135 Marginal Way  
Plan Amendment  
Five Liver Co.

**CITY OF PORTLAND, MAINE  
DEVELOPMENT REVIEW APPLICATION  
PLANNING DEPARTMENT PROCESSING FORM  
DRC Copy**

Re: 135 Marginal Way Site Plan Amendment

**FIGURE I - 12**  
**BITUMINOUS SIDEWALK AND DRIVEWAY CONSTRUCTION**

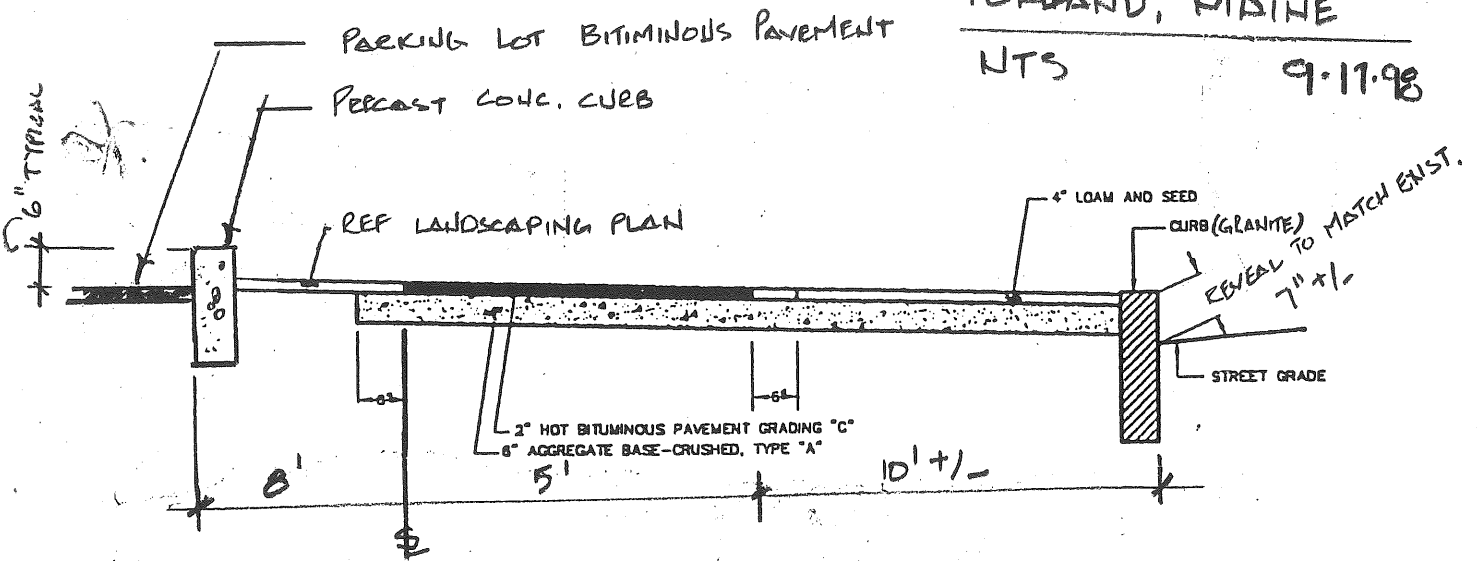
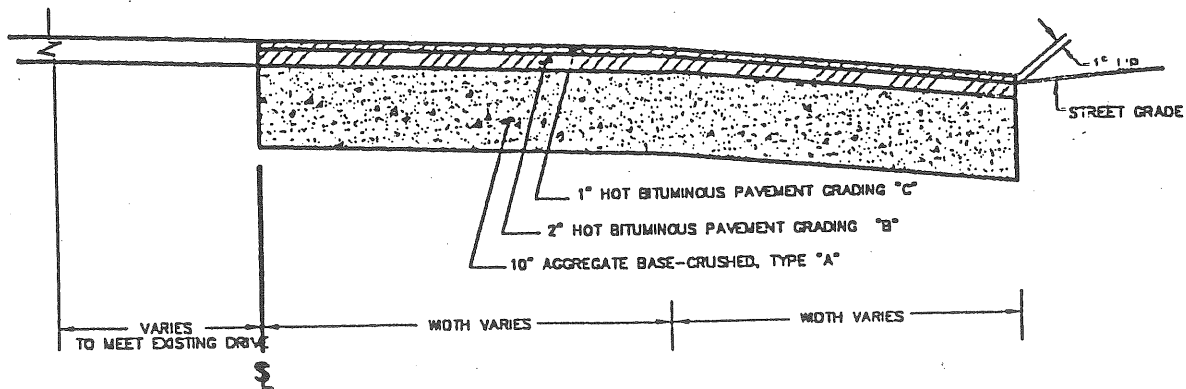
The site plan submitted on Wednesday reflects a bituminous sidewalk.

- 3. ~~[Within five (5) years of site plan approval]~~, the applicant shall plant eight (8) trees within the interior of the parking lot in a well distributed pattern, subject to review and approval of the location and species by planning staff.
- 4. That the site plan be revised reflecting the comments of the Development Review Coordinator and Public Works (see previous comments.)
- 5. That the Marginal Way sidewalk shall be constructed of concrete.

NOTE: KEEP SITE PLAN FOR EXACT SITE DIMENSIONS + PARKING LAYOUT  
 GENERAL / ADDITIONAL NOTES:  
 LANDSCAPING SHALL MEET THE "ARBORICULTURAL SPECIFICATIONS AND STANDARDS OF PRACTICE AND LANDSCAPE GUIDELINES" OF THE CITY OF PORTLAND, MAINE. TECHNICAL AND DESIGN STANDARDS ARE OTHERWISE SPECIFIED.

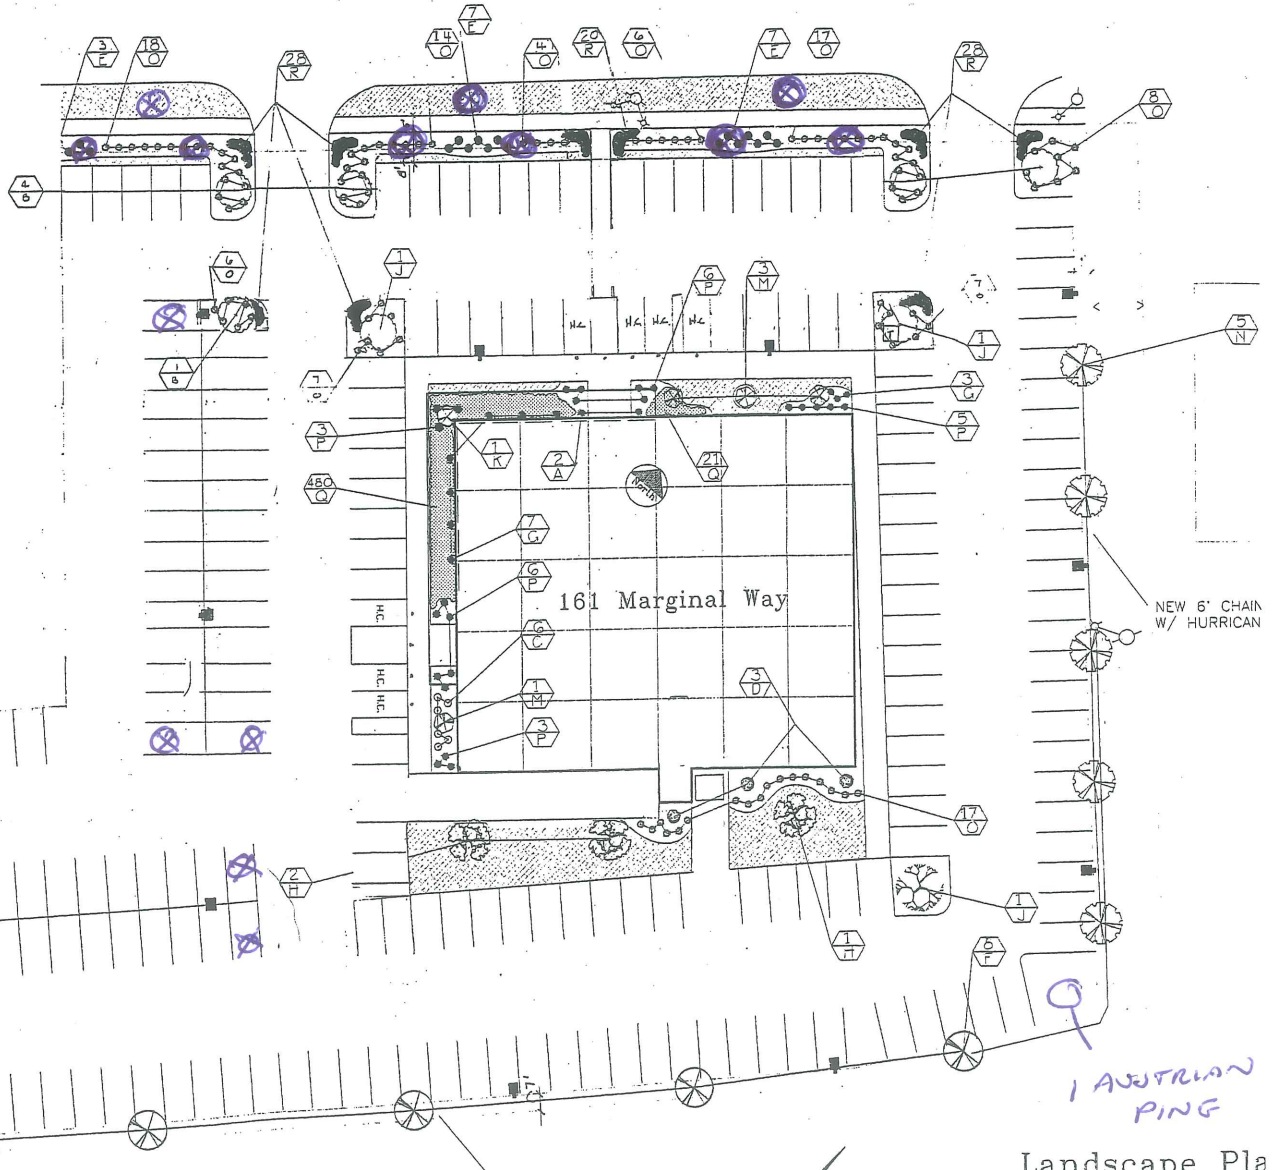
Jeff Tarling, City Arborist, recommends that street trees be introduced along Marginal Way. Currently, the site plan shows only five (5) street trees near the 350-foot Marginal Way street frontage. Mr. Tarling also recommends that an evergreen tree be planted in each (vacant) corner of the rear parking lot. This would total three (3) trees.

1. That the exterior lighting plan shall be revised for staff review and approval, substituting the wall-mounted fixtures with a cut-off fixture.
2. That the landscaping plan shall be revised for staff review and approval, including new trees along Marginal Way and three evergreen trees in the rear corners of the parking lot.
